Town Council Meeting

October 10, 2022 at 6:00 PM Howey-in the-Hills Town Hall 101 N. Palm Ave., Howey-in-the-Hills, FL 34737

Consideration and Approval: (First Reading) Ordinance 2022-019 - Reserve/Hillside GrovesDevelopment - PUD Amendment

- 4. Consideration and Approval: Appointment of Alan Hayes to the Planning and Zoning Board
- 5. Consideration and Approval: **Howey Self Storage Final Site Plan Submission**
- 6. Discussion: Retired Landfill Historic Overview
- 7. Consideration and Approval: Fencing around Town Lift Stations in Central Park and Griffin Park

JEFFREY A. SEDLOFF

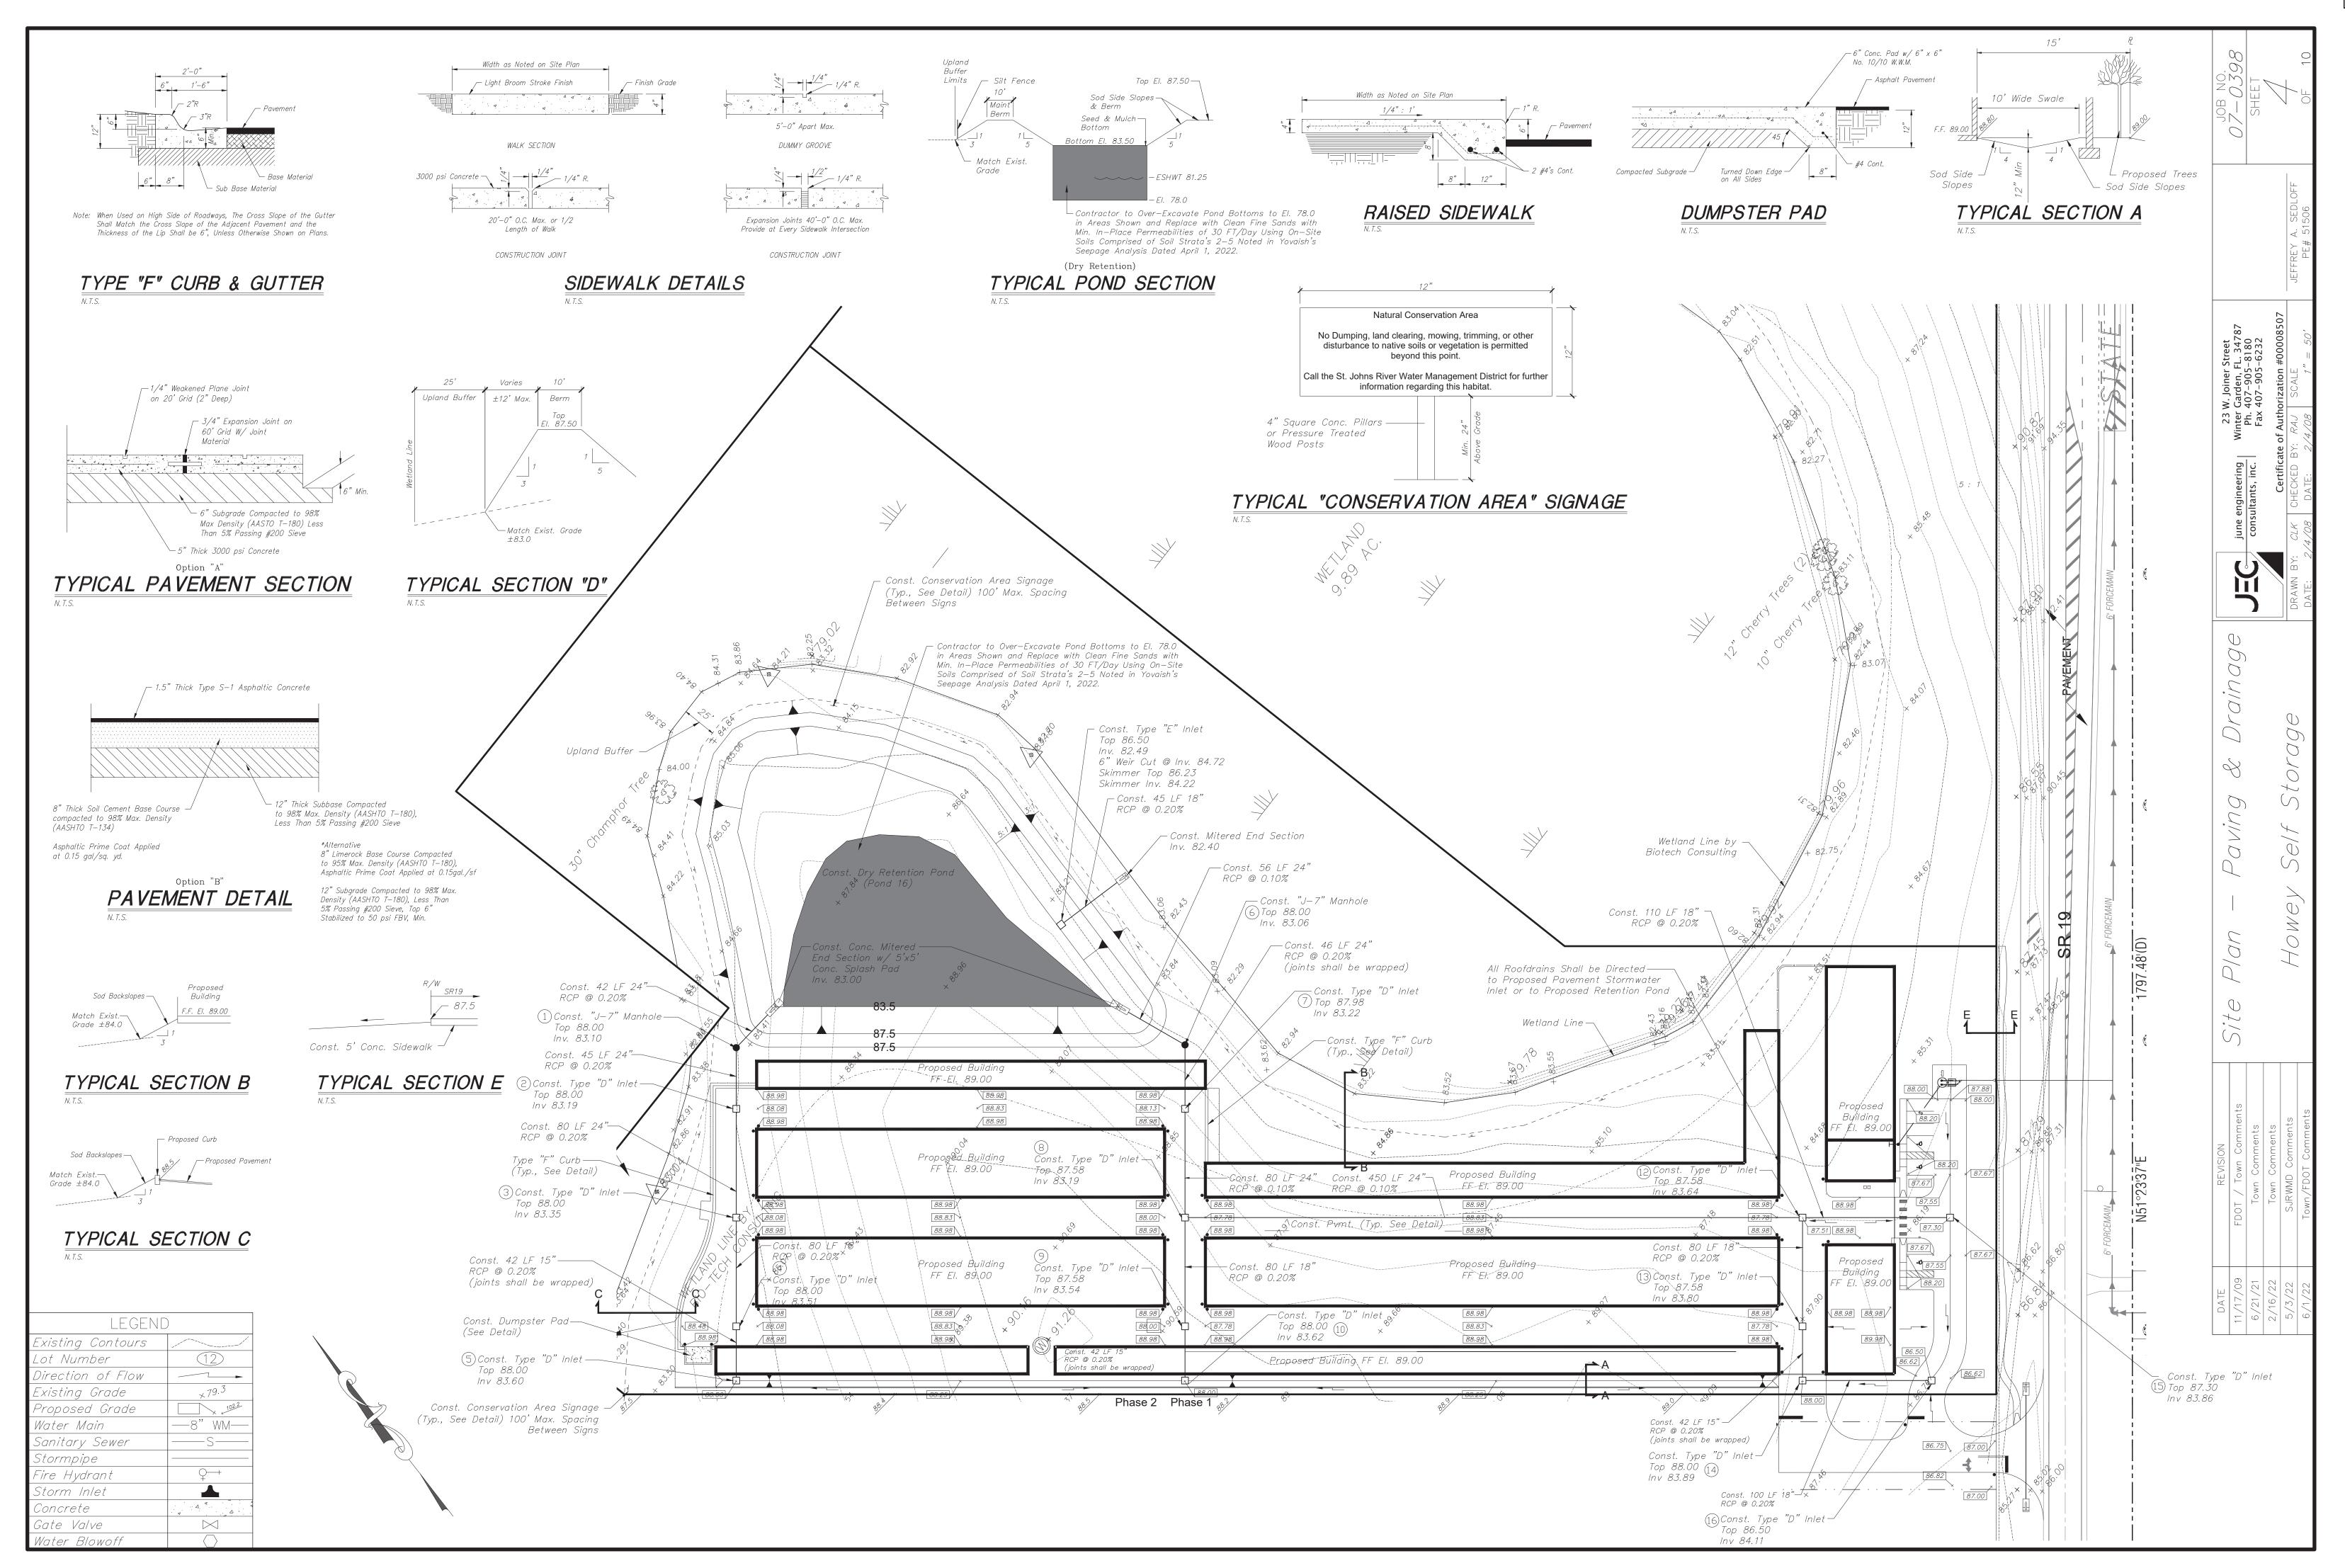
RESPONSE: The survey has been added as a separate page on sheet 5b.

RESPONSE: Parking calculations and additional building dimensions have been added to sheet 3. Stop bars & signs have been added and called out on sheets 4 and 6.

RESPONSE: The sidewalk has been added to section E on sheet 4.

RESPONSE: We have added sheet 5a to show the truck turning radii.

RESPONSE: Proposed crosswalk striping has been called out on sheet 3.

RESPONSE: The existing 4" water main has been shown on sheet 6 of the revised plans. We have shown this main to remain.

9. Update the Utility Connection Detail on sheet 6 to add the ex. 4" WM, correct the new WM size, remove the FM connection note.

10. Identify on the plan the water main jumper locations and BacT testing points. Add the town's temporary jumper detail PW-5A.

RESPONSE: Sample points SP-1, SP-2 and SP-3 are shown on sheet 6. The temporary jumper detail is shown on sheet 9.
